**April 21, 2025**

**Project: FTW Apron B and Taxiway G Reconstruction Project  
TxDOT CSJ No. 2502MCHAM  
Addendum No. 1  
To Plans and Contract Documents**

**To:** Attendees  
**From:** Alex Jessop, PE  
**RE:** Fort Worth Meacham International Airport (FTW)  
Apron Bravo and Taxiway G Reconstruction  
Pre-Bid Meeting Minutes

BATCH PLANT  
LOCATION PLAN

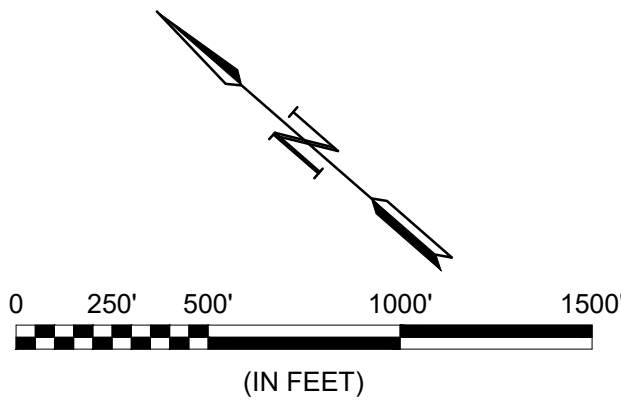
9. What is the utility allowance?
  - a. This allowance will be \$40,000. See the revised bid form included with this addendum.
10. Will a batch plant be allowed at the airport?

- a. No, a batch plant will not be permitted on the airport. See revised sheet GC-003 for potential batch plant location.
11. Is badging required for all contractor employees?

POTENTIAL BATCH  
PLANT LOCATION  
SEE INSET VIEW  
THIS SHEET

7. IF THE CONTRACTOR ELECTS TO CONSTRUCT A TEMPORARY BATCH PLANT, THE CLEARING, GRUBBING, STABILIZATION, EROSION CONTROL MEASURES, AND SITE PREPARATION OF THE SITE WILL NOT BE MEASURED AND PAID FOR SEPARATELY AND SHALL BE SUBSIDIARY TO THE ITEM CONTAINED. THE CONTRACTOR IS RESPONSIBLE FOR RESTORING THE BATCH PLANT LOCATION SITE TO THE ORIGINAL CONDITION AT NO ADDITIONAL COST. RESTORATION OF THE SITE SHALL NOT BE MEASURED AND PAID FOR SEPARATELY.

8. ACCESS TO THE BATCH PLANT SITE SHALL BE COORDINATED WITH THE AIRPORT STAFF. THE CONTRACTOR SHALL MAINTAIN ACCESS CONTROL AT ALL TIMES THE GATE IS OPEN FOR CONCRETE OPERATIONS. WHEN NOT IN OPERATION THE CONTRACTOR WILL BE RESPONSIBLE FOR SECURING THE SITE.

EXISTING  
CONDITIONS AND  
DEMOLITION PLAN 1

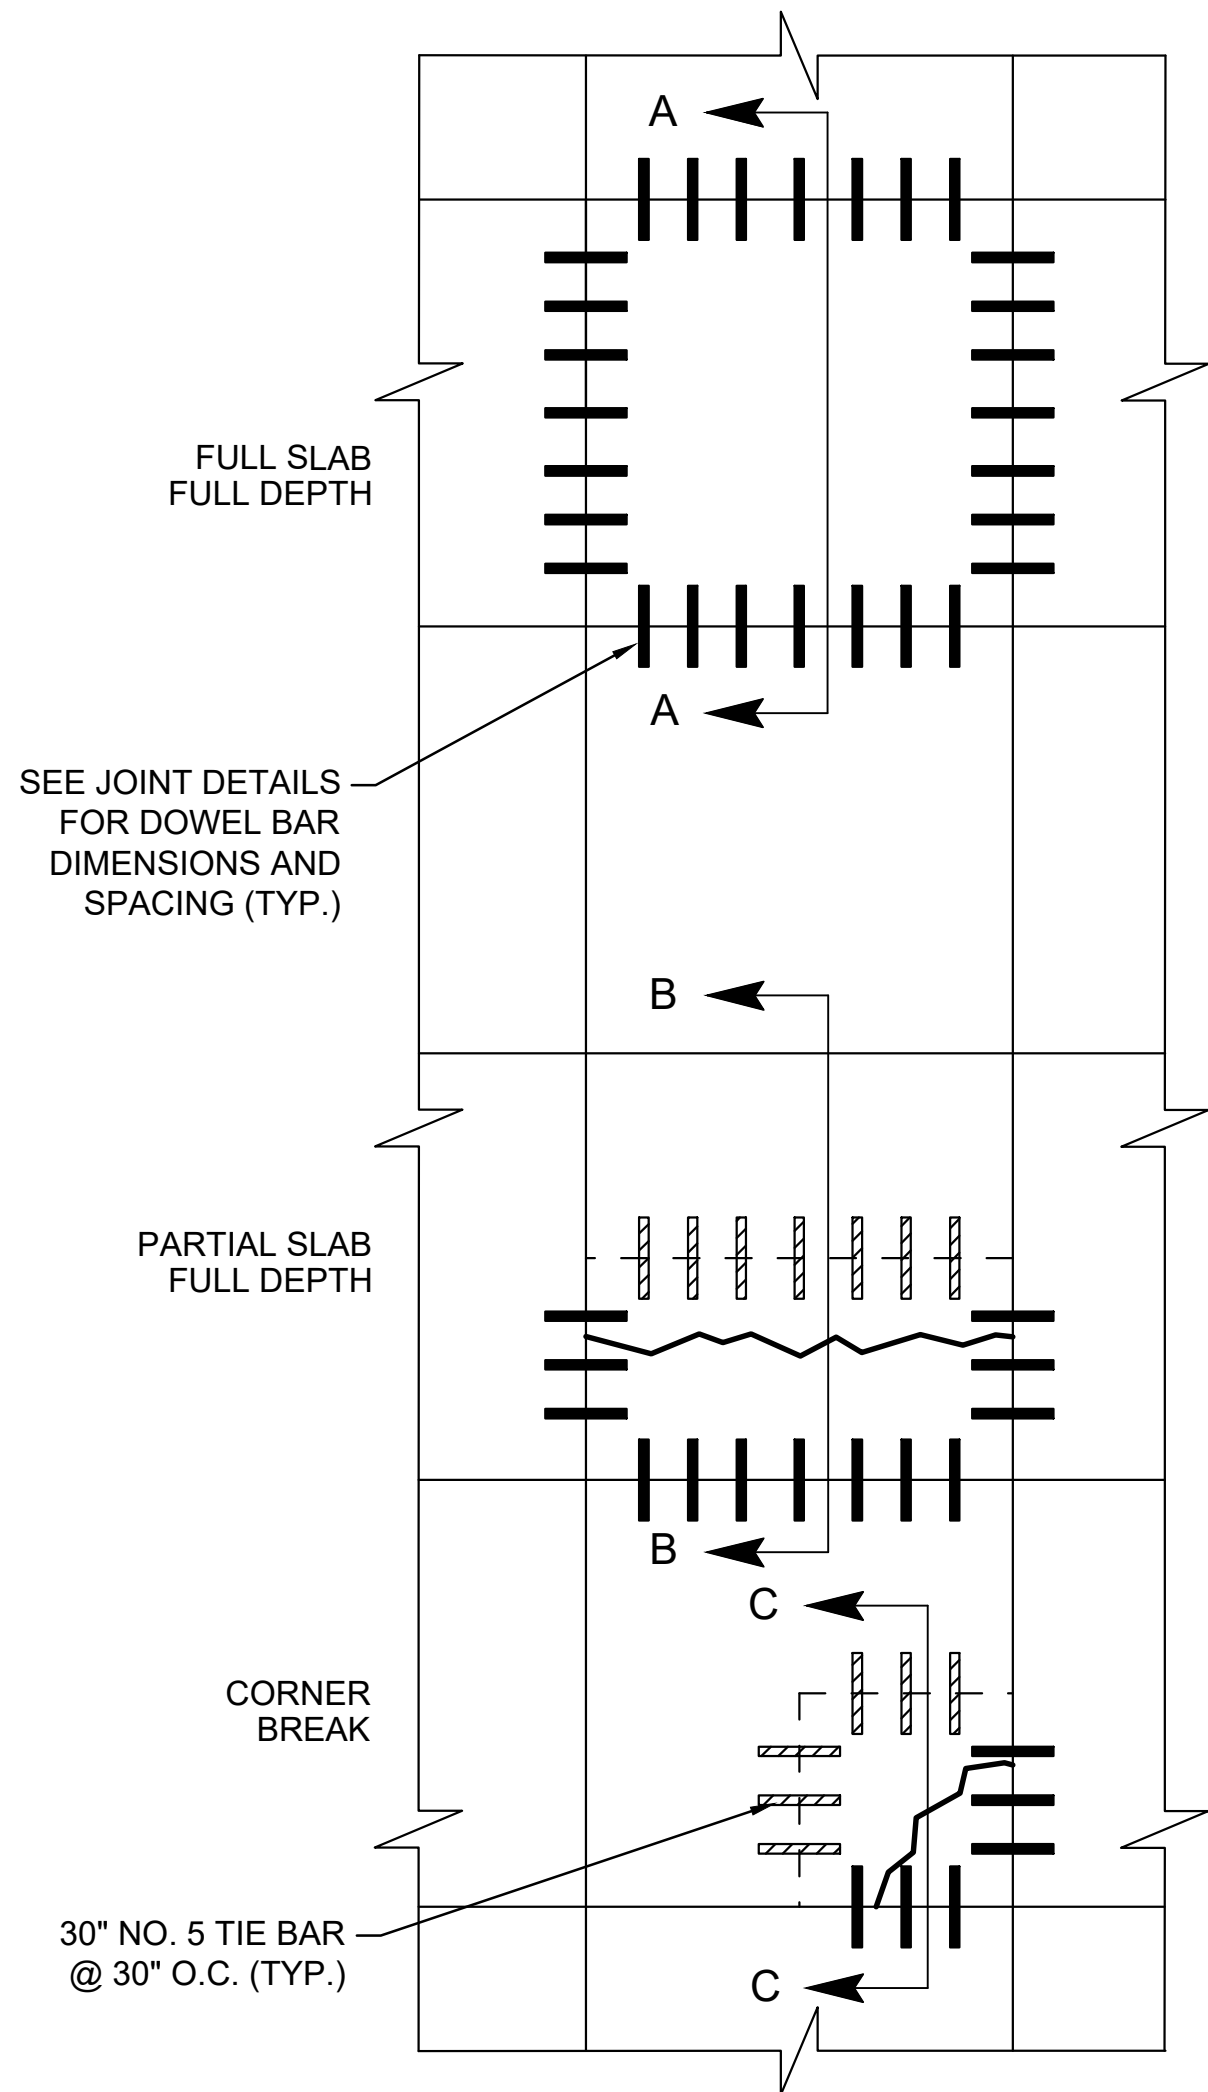
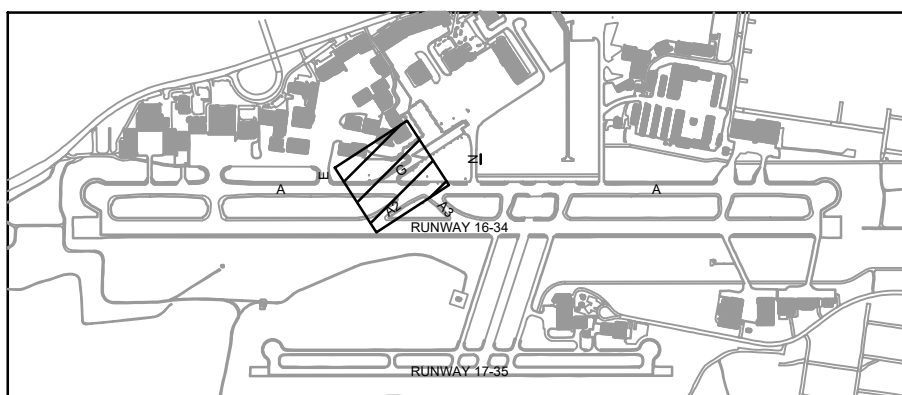
19. Drawings CD-101 (Sheet 29) and CC-101A (Sheet 32) indicate an existing inlet to be removed; however, there is no Bid Item associated with this work. Please advise on how this removal will be compensated.

33. Please clarify the demolition quantity for the base bid. There seems to be a discrepancy in quantity between the concrete removal less than 10” thickness and greater than 10” thickness.

- a. This work will be covered under Item SS-140-5.1. See the revised bid form included with this addendum.
20. Drawing CC-101 (Sheet 39) shows Proposed Structure A2 connecting to an existing 24" drain line. The Storm Drain Details do not include information on the connection or collar detail for tying into the existing pipe. Please provide these details.

- Please see the revised sheet CD-101 which includes delineation for concrete thickness removal areas.

**PAVEMENT REHABILITATION**  
DETAILS 1 - ADD ALT

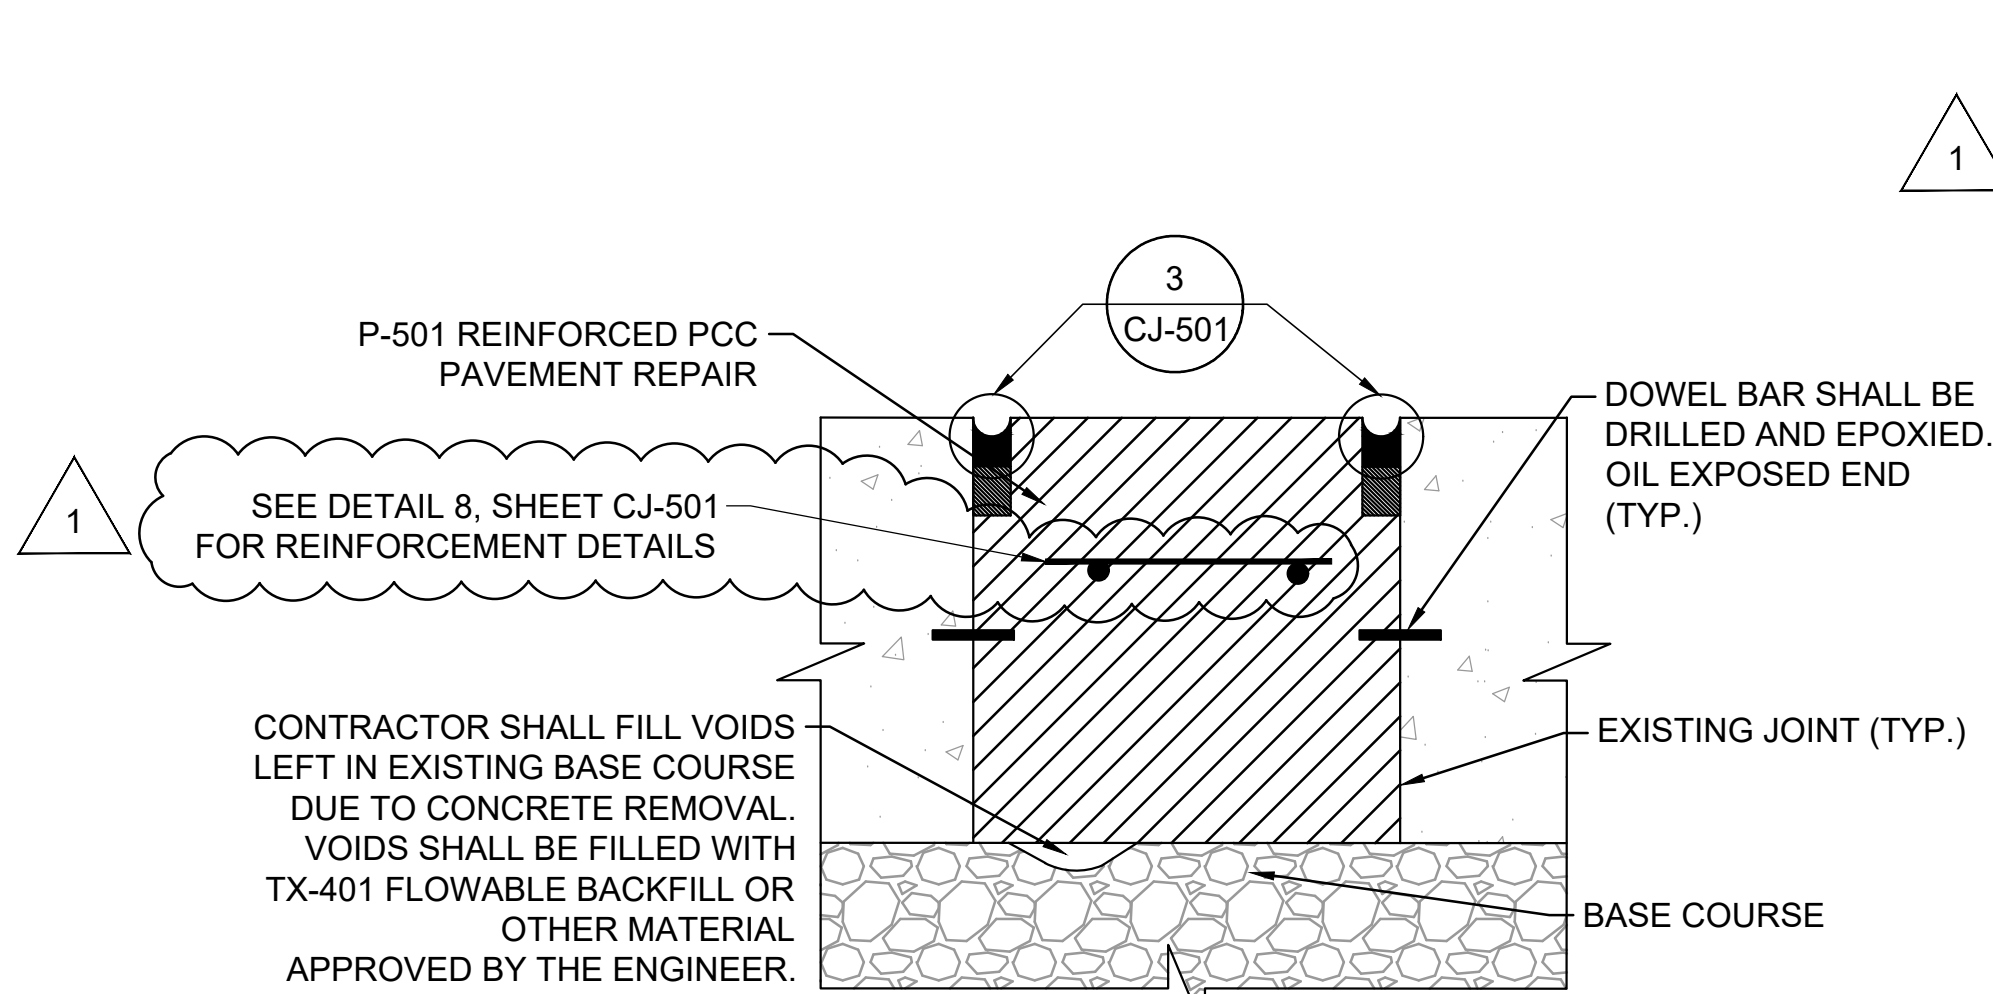
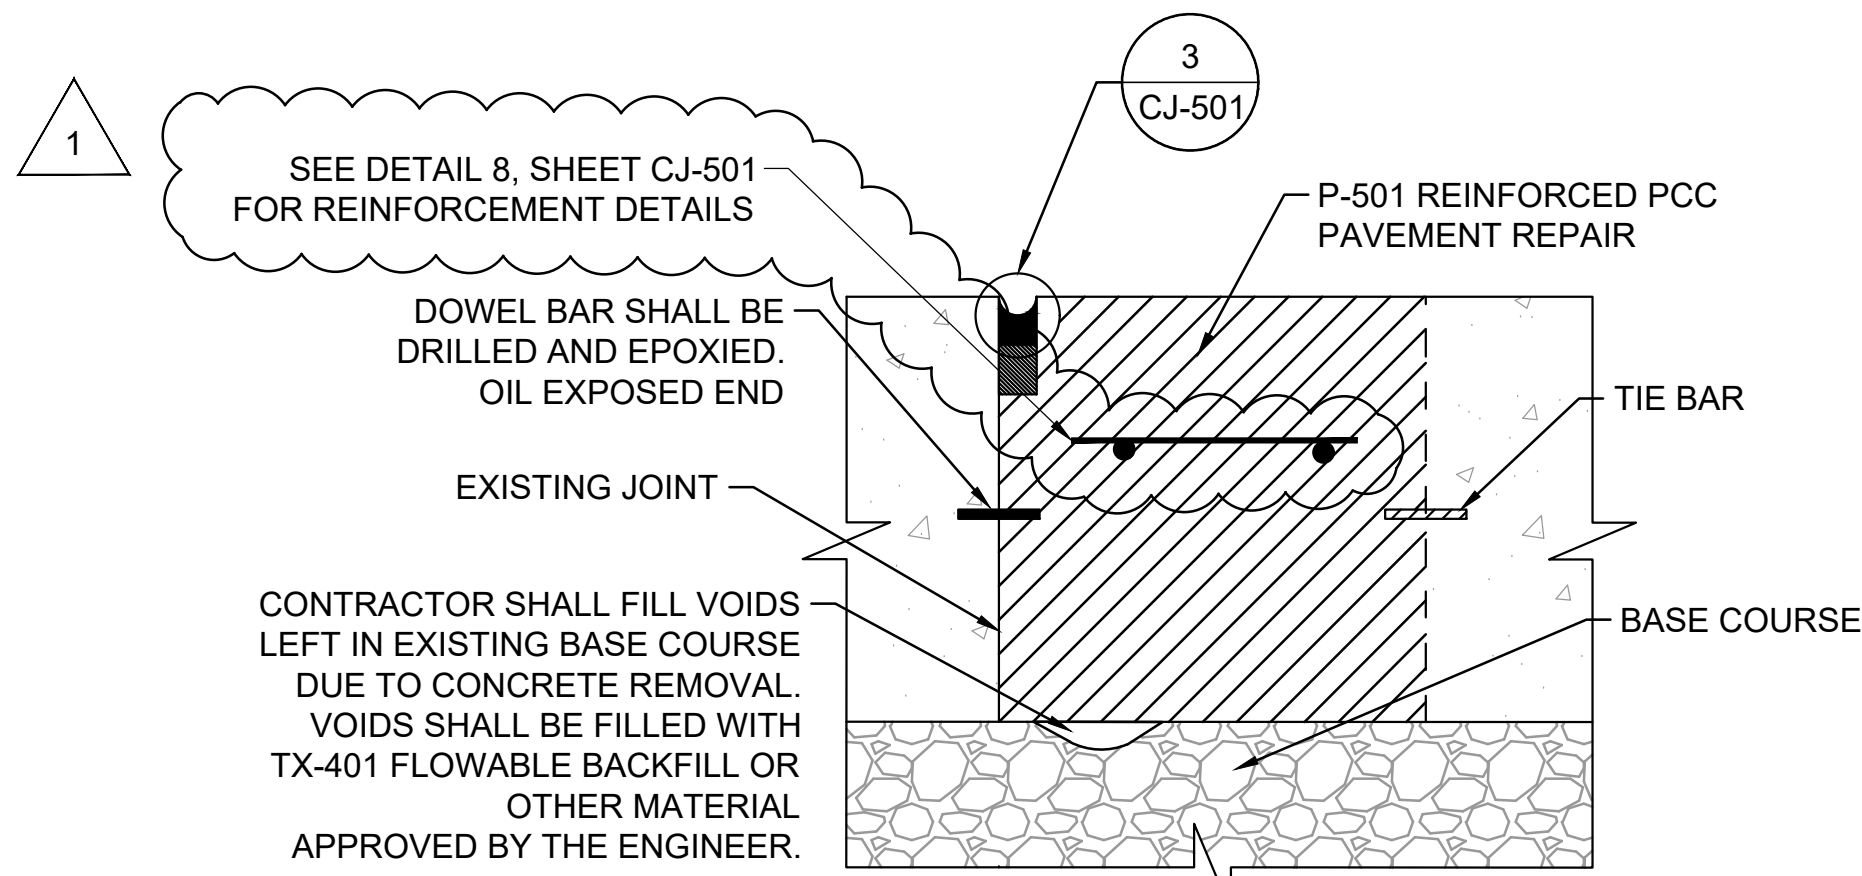
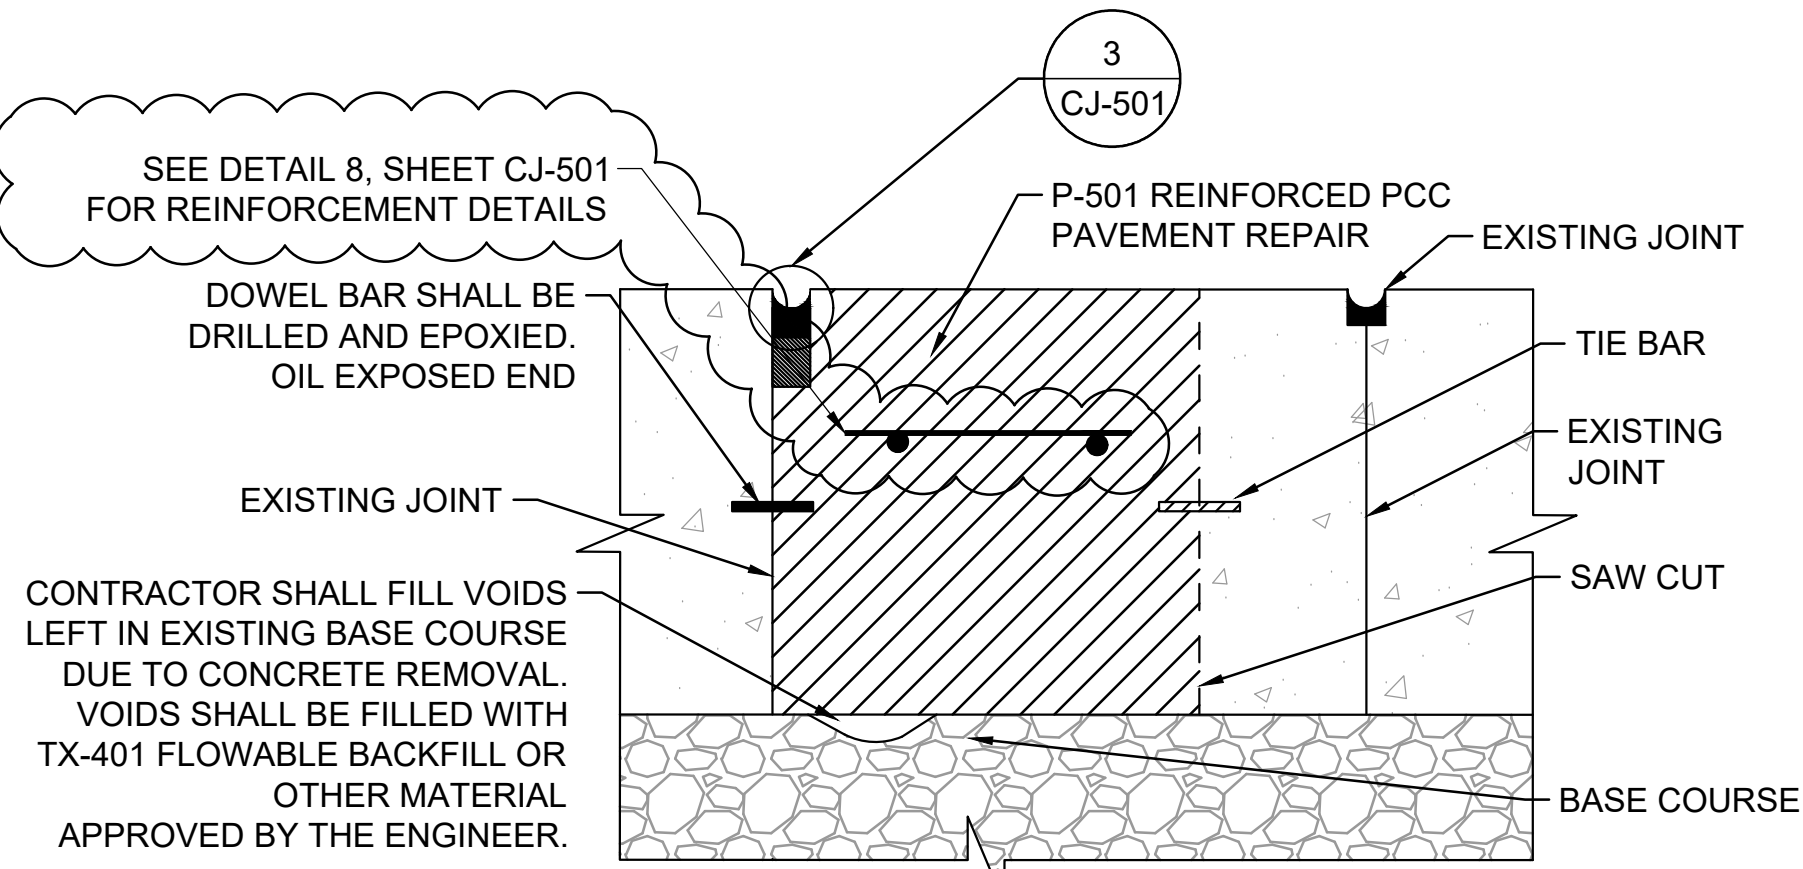
15. Will the panels included in additive alternate 1 require reinforcement? What thickness will these be?
  - a. Yes, the panels will be reinforced. The thickness of these proposed panels will match the existing concrete thickness removed. See revised sheet CR-501 included in this addendum.

34. Under Item P-101-5.6, will the contractor be asked to replicate the existing pavement depth and design (including any reinforcing steel encountered) or replace the damaged areas with 14" pavement?

- a. See revised sheet CR-501 included with this addendum. The thickness of these proposed panels will match the existing concrete thickness removed. See revised sheet CR-501 included in this addendum.
